Product Change Notification

PCN-IFC-2164-2018

Business Unit	Product Line Code	Type of Change	Action	Date of Issue
IFC - Industrial Field Connectivity	BF1	Product Change Notification	Notify Distributors and Field	8/23/2018

Description for Product Change Notification

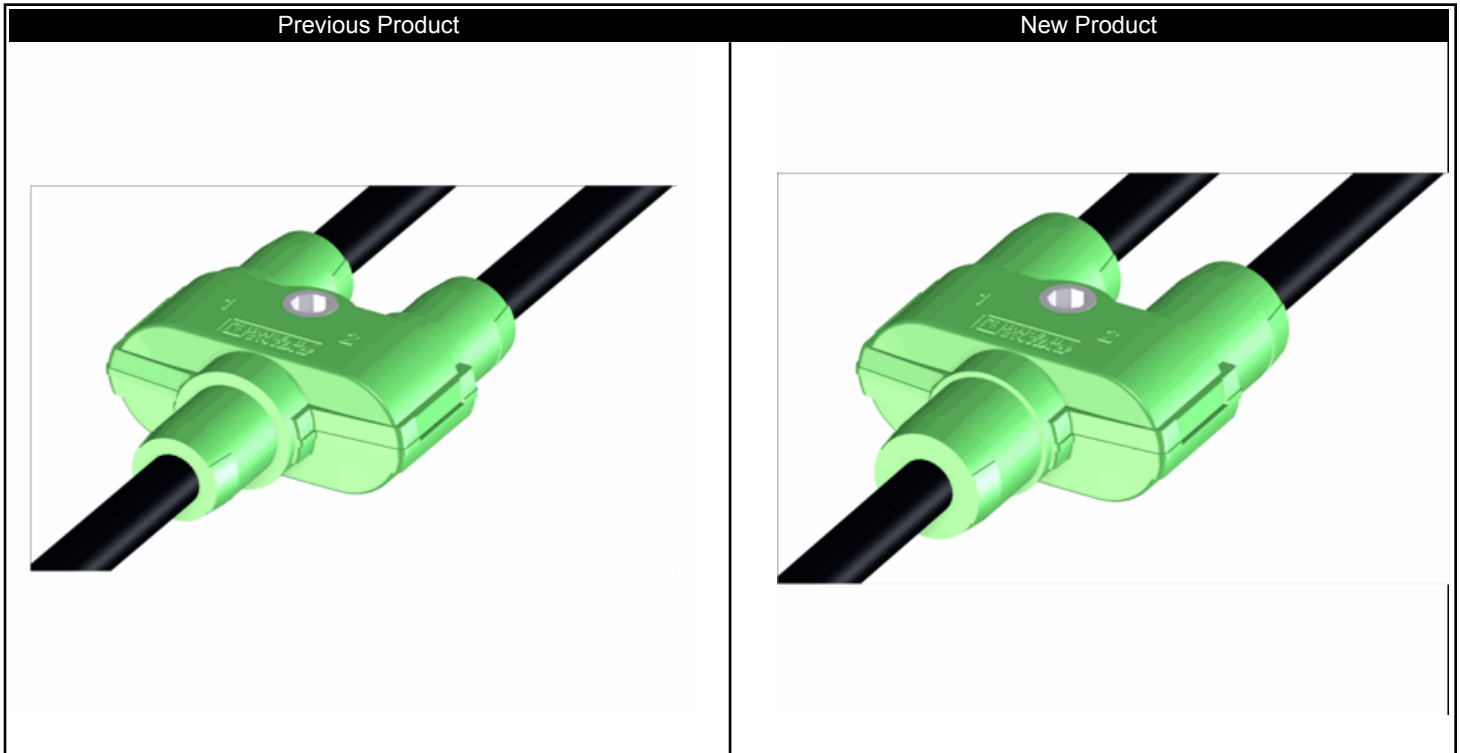
The in-line Y-distributor mold used on assembled cables will increase in diameter from 5.8 mm to 6.8 mm at the cable outlet. The design change was made to allow for the processing of larger cable diameters. All electrical and mechanical data will be unchanged.
